## IMMULITE® IMMULITE® 1000

### IMMULITE and IMMULITE 1000 Total Testosterone Positive Bias

This response form is to confirm receipt of the enclosed Siemens Healthcare Diagnostics Urgent Field Safety Notice IMC 23-02.A.OUS dated October 2022 regarding IMMULITE and IMMULITE 1000 Total Testosterone Bias. Please read each question and indicate the appropriate answer.

**Figure 1. Current IMMULITE/IMMULITE 1000 Total Testosterone vs. IMMULITE 2000/IMMULITE 2000 XPI Total Testosterone Graph**

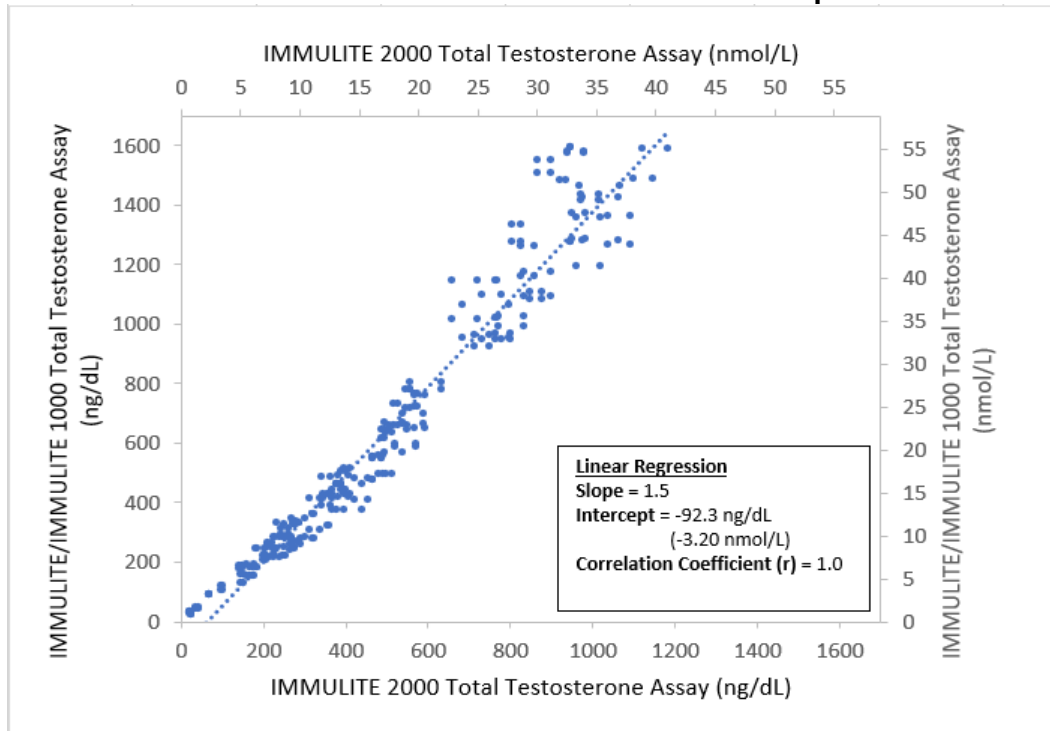
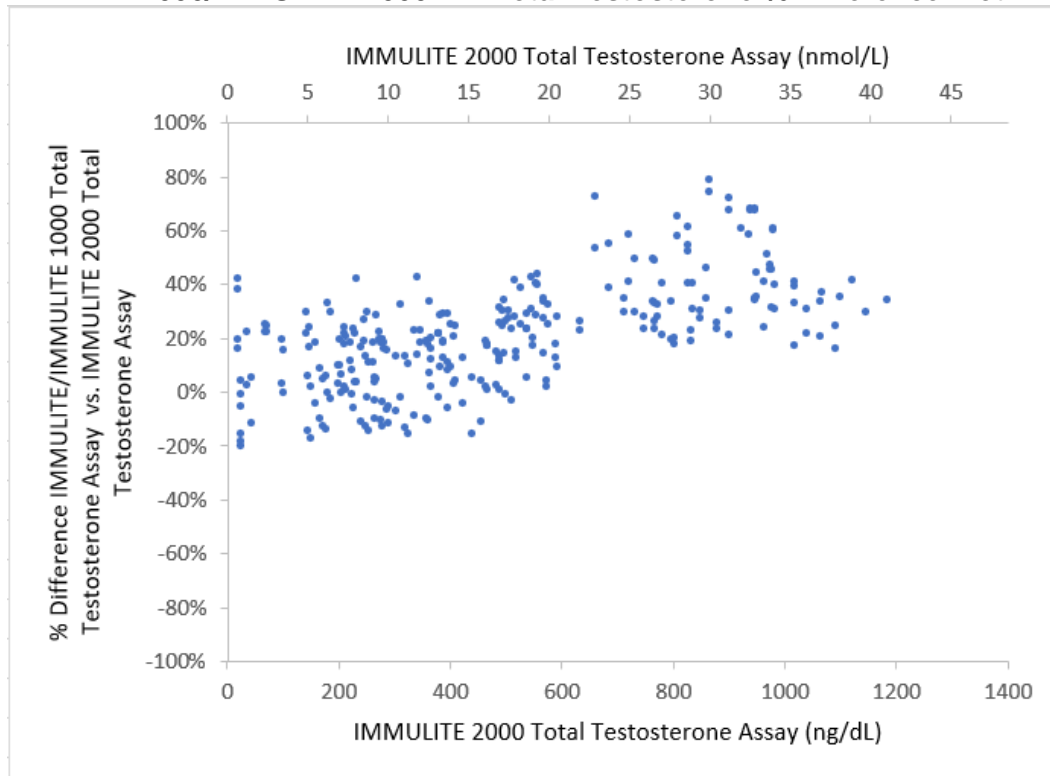
Siemens Healthcare Diagnostics Inc. has confirmed an average positive bias of 40% for testosterone concentrations of approximately 660 ng/dL (22.9 nmol/L) and above with the IMMULITE/IMMULITE 1000 Total Testosterone Assay when compared to the IMMULITE 2000/IMMULITE 2000 XPi Total Testosterone Assay. The observed bias is not proportional across the assay range; biases below a dose of approximately 660 ng/dL are equivalent to historical performance. See Additional Information section below for details.

IMMULITE/IMMULITE 1000 Total Testosterone performance compared to IMMULITE 2000/IMMULITE 2000 XPi was evaluated with 100 serum samples across the assay calibration range (20 – 1600 ng/dL; 0.7 – 55 nmol/L) and two kit lots per platform. Figure 1 shows the biases observed for results within the assay calibration range when comparing representative lots (516 and below) of IMMULITE/IMMULITE 1000 Total Testosterone Assay to the IMMULITE 2000/IMMULITE 2000 XPi Total Testosterone Assay.

- Please review this letter with your Medical Director.
- You may continue use of the IMMULITE/IMMULITE 1000 Total Testosterone Assay kit lots listed in Table 1 to report values below 660 ng/dL (22.9 nmol/L) until you receive replacement product in your laboratory. Refer to Figures 1 and 2 for IMMULITE/IMMULITE 1000 Total Testosterone bias information.

**Figure 3. IMMULITE/IMMULITE 1000 Total Testosterone Kit Lot 550 vs. IMMULITE 2000/IMMULITE 2000 XPi Total Testosterone Kit Lots 635, 638, and 639 Graph**

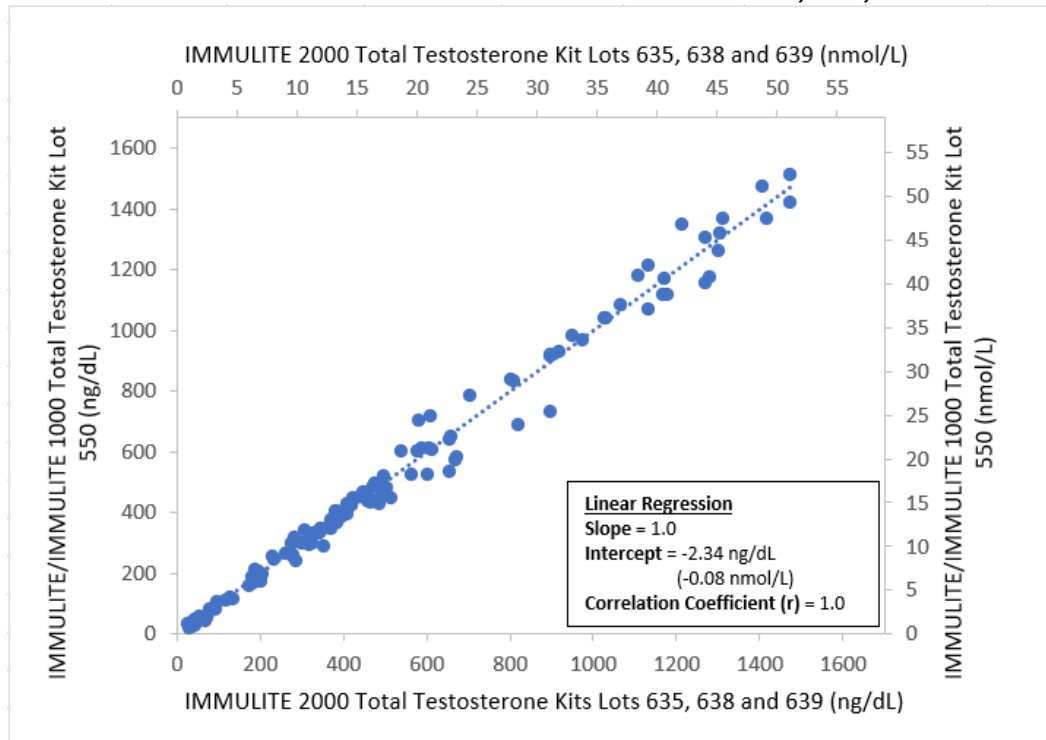
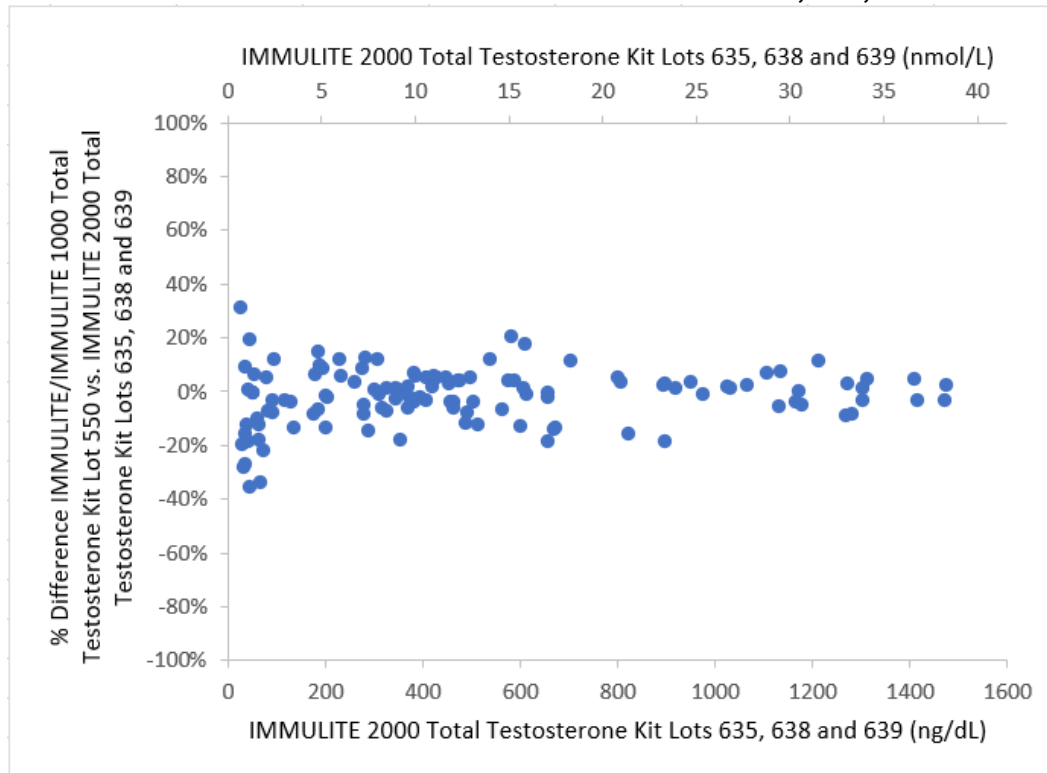
Evaluation of the IMMULITE/IMMULITE 1000 Total Testosterone assay compared to IMMULITE 2000/IMMULITE 2000 XPi utilized 123 patient samples covering the assay calibration range (20 – 1600 ng/dL; 0.7 – 55 nmol/L) with IMMULITE/IMMULITE 1000 Total Testosterone Kit Lot 550 versus IMMULITE 2000/IMMULITE 2000 XPi Total Testosterone Kit Lots 635, 638, and 639.

Figures 3 and 4 demonstrate Total Testosterone result alignment between the IMMULITE/IMMULITE 1000 and IMMULITE 2000/IMMULITE 2000 XPi Systems has been restored.

Alignment to the IMMULITE 2000/IMMULITE 2000 XPi Total Testosterone Assay has been restored with IMMULITE/IMMULITE 1000 Total Testosterone Assay Kit Lots 550 and above (available in October 2022).

**Figure 5. IMMULITE/IMMULITE 1000 Total Testosterone Kit Lot 550 vs. Kit Lot 515 Graph**

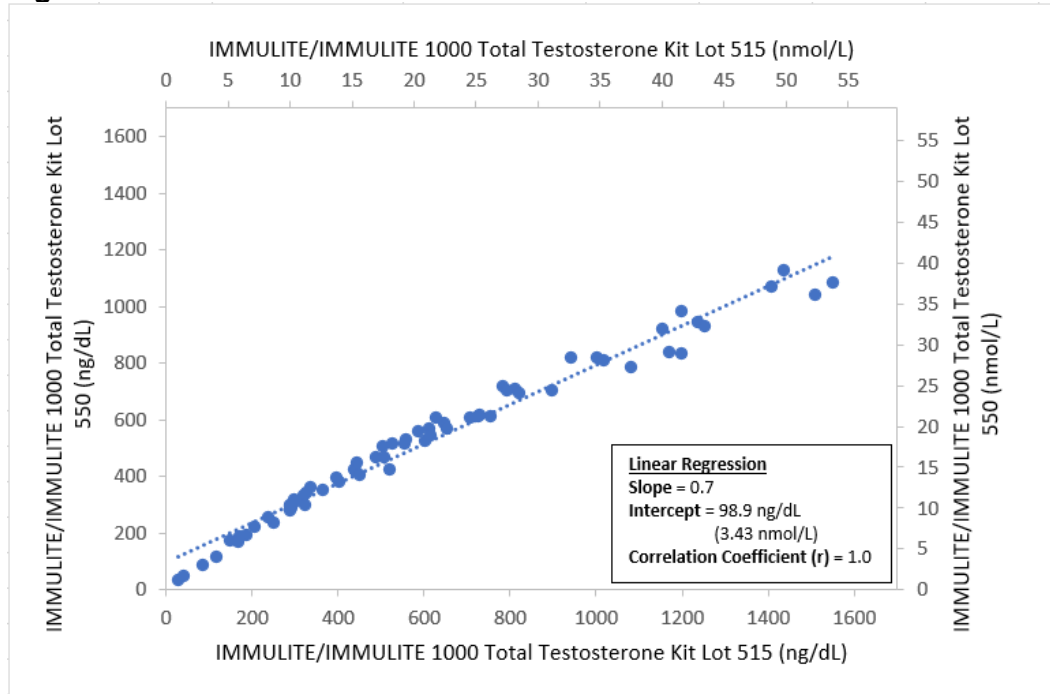
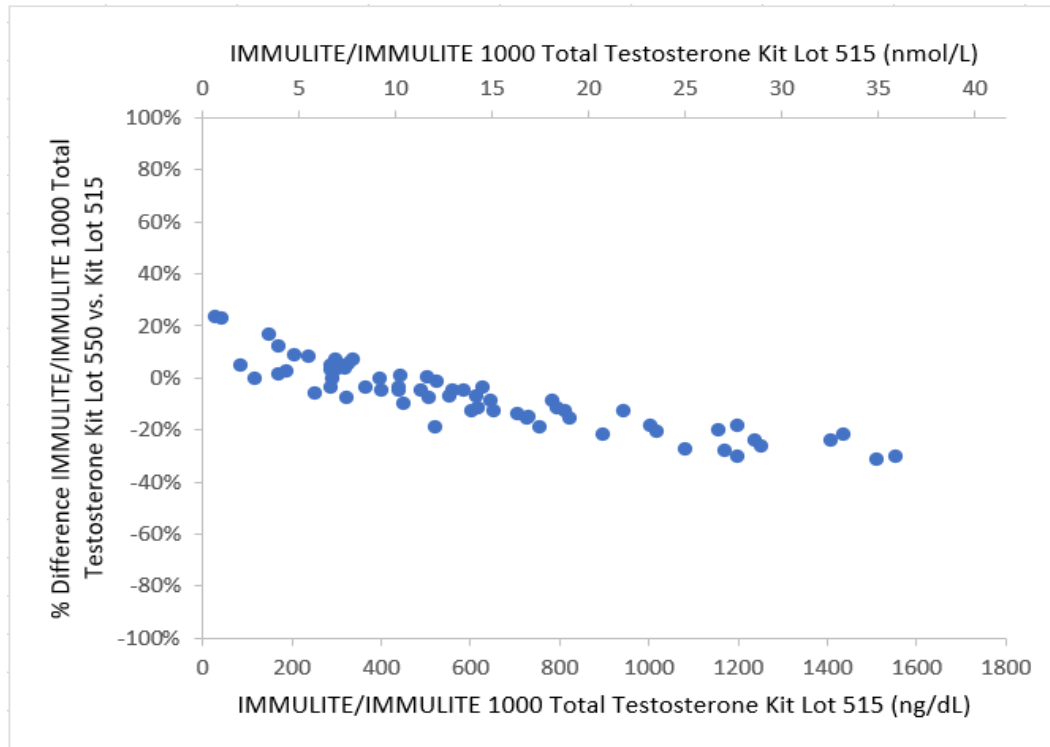
After restoring alignment to the IMMULITE 2000/IMMULITE 2000 XPi, Siemens completed internal testing to evaluate the performance of IMMULITE/IMMULITE 1000 Total Testosterone Kit Lot 550 compared to IMMULITE/IMMULITE 1000 Total Testosterone Kit Lot 515. Method comparison studies included 65 samples across the assay calibration range (20 – 1600 ng/dL; 0.7 – 55 nmol/L) to evaluate the performance. The observed method comparison results are representative of IMMULITE/IMMULITE 1000 Total Testosterone Kit Lot 550 compared to IMMULITE/IMMULITE 1000 Total Testosterone Kit Lot 515.

Figures 5 and 6 show the approximate overall average negative 7% shift that is expected when transitioning to Kit Lot 550 and above.

Customers will observe a negative shift when transitioning from the kit lots listed in Table 1 to the restored Kit Lots 550 and above. See Additional Information section below for details on the expected shift.
